WALL SIGN DETAIL (A)

WEST VILLAGE
236 WEST WOOL

Subject: Minor Modification to Special Use Permit No. 1353

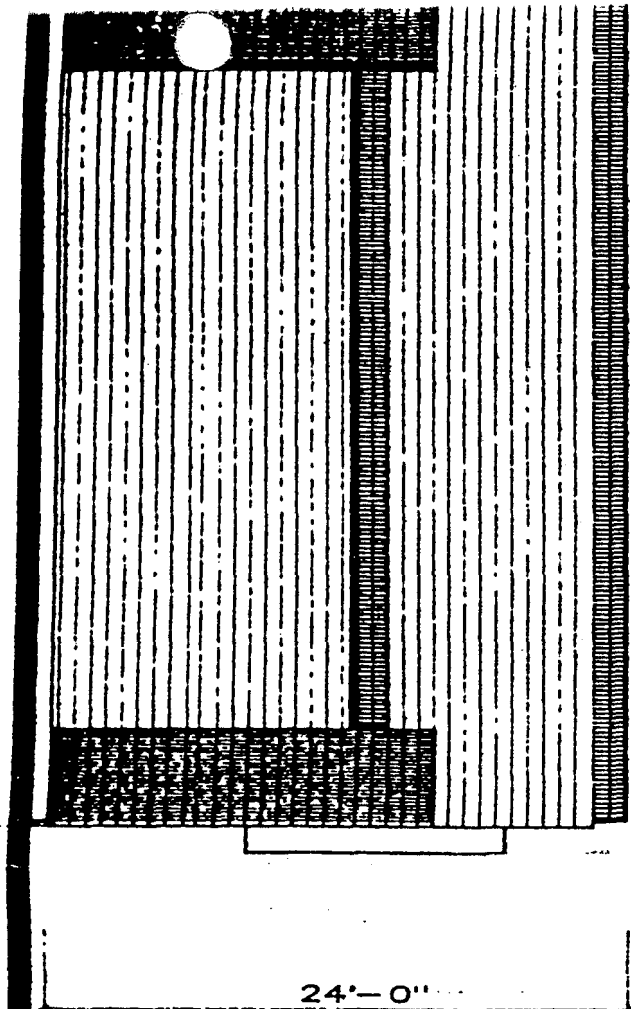
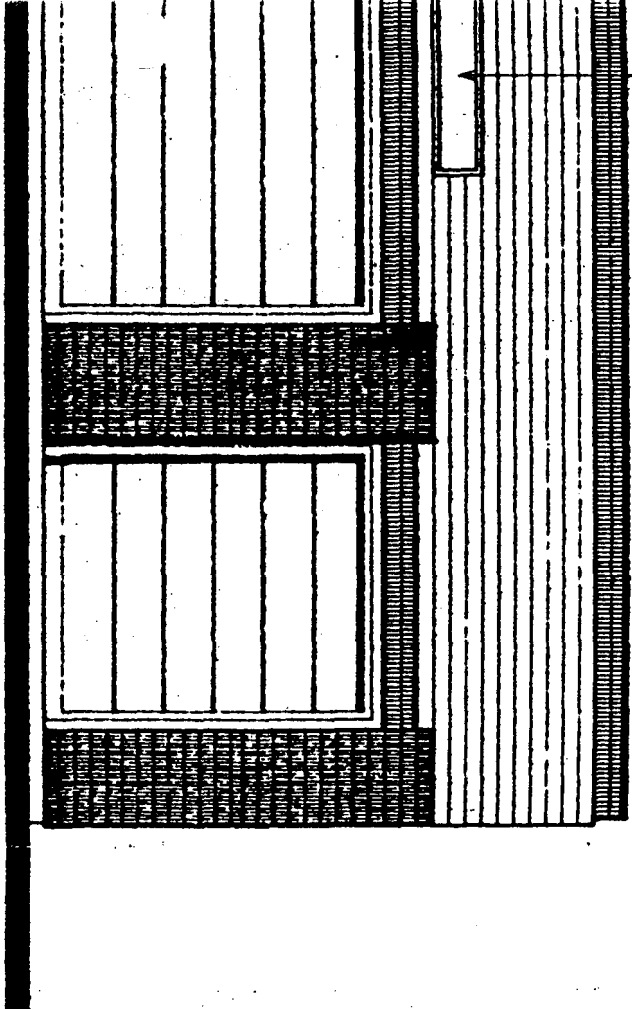
Although the DRC found the types of building and monument signs to be acceptable, the amount of sign area exceeds the total amount of 145 square feet permitted for this project. It is suggested that you allocate the sign area as per the example when you resubmit your building permit to the Permit Center:

<u>SIGNS</u>	<u>Sq. Ft.</u>
Monument Sign	50 sq. ft.
Tenants (6- total)	
(15.8 sq. ft. per tenant x 6) =	<u>95 sq. ft.</u>
TOTAL:	145 sq. ft.

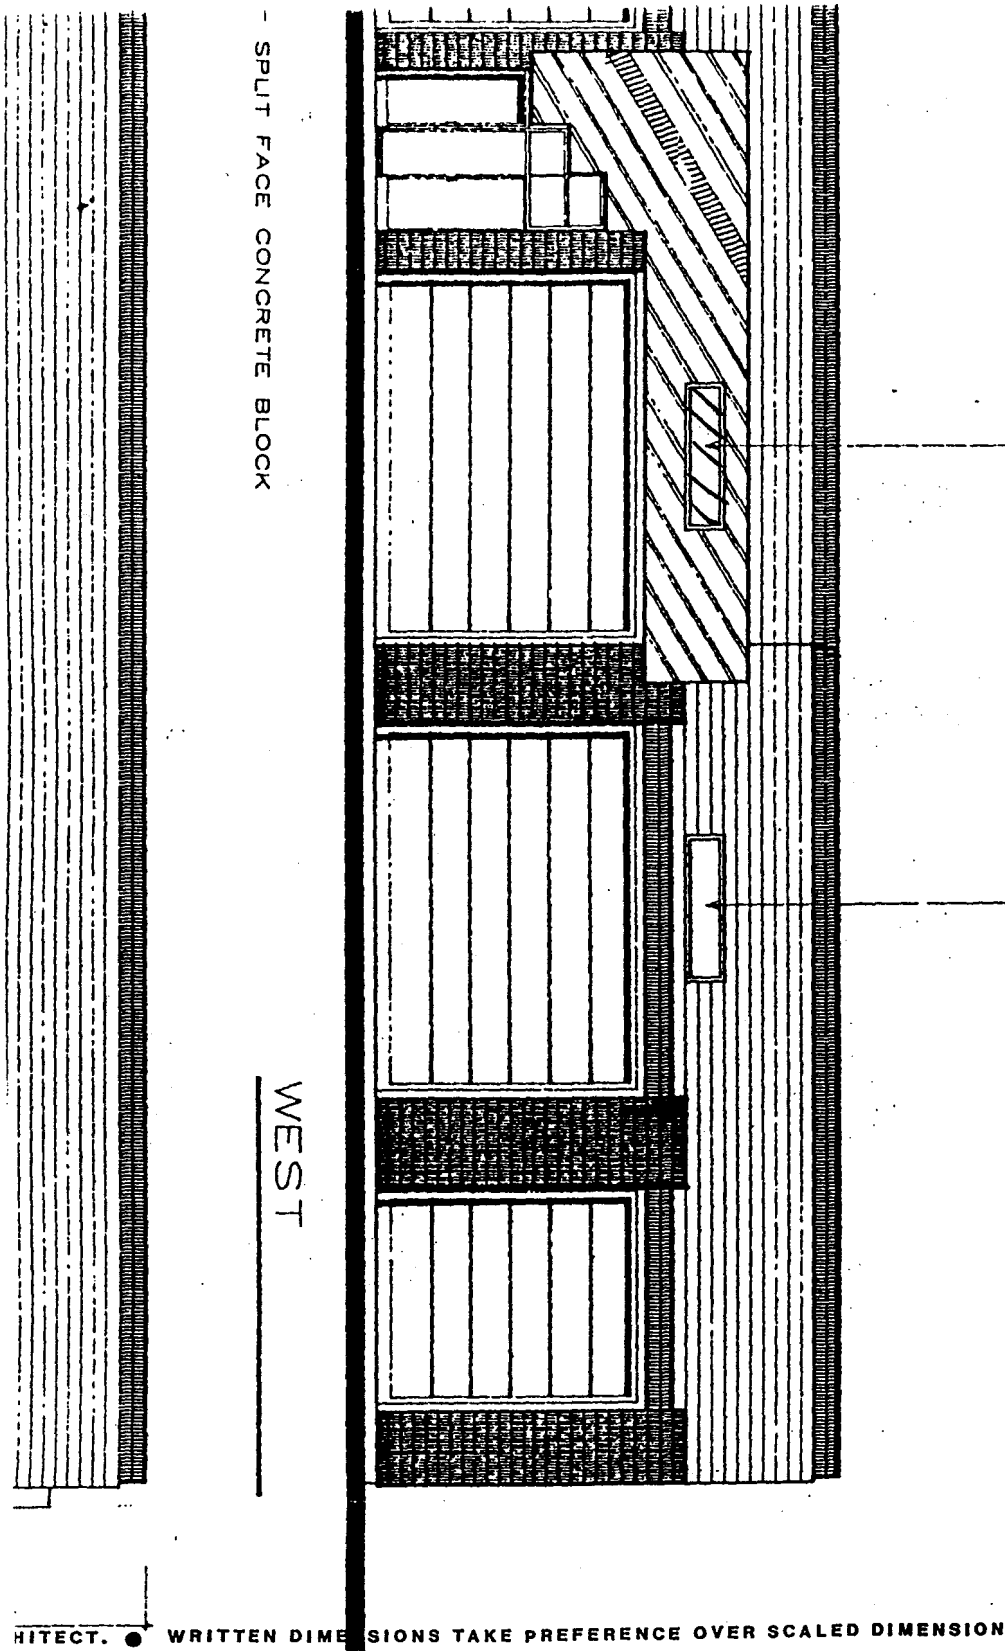
- Delete two office areas from the site plan and elevations
- Add additional roll-up door and auto service bay
- Add landscape planter at the end of the parking bay (aisle)

The modifications requested above are hereby approved. Signed copies of the plans have been enclosed with this letter and a copy will be placed in the project file. This approval is only for the minor modification of an approved project and building permits must be pursued separately through the Building Division Permit Center.
